Date May 18, 2026
To Nick Govan, Planning Commission
From Aric Thorne, PE
Subject Site Plan Review: Cascade Engineering, 4950 37th St SE

I have reviewed the site plan for the Buursma Plant Addition of Cascade Engineering by Nederveld. The applicant is proposing a building addition to an existing industrial and manufacturing plant.

RE: 4950 37th Street SE Pre-Application Conference Comments

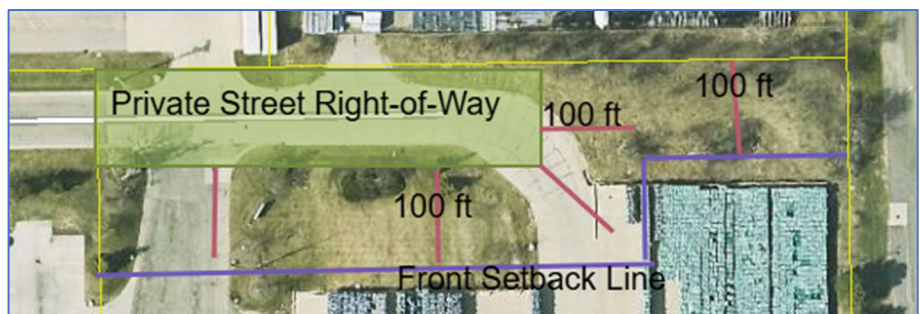
- Setback determination. The north side of your property would be considered the front yard. The property is Industrial with 100-foot setback. Setback is determined from the private street right-of-way or front lot line. (See rough image below). It will be important that you identify the private street right-of-way for 37th Street and

include it in your plans. (Section 4.15 Current ZO, Definitions section – Building Setback New ZO)
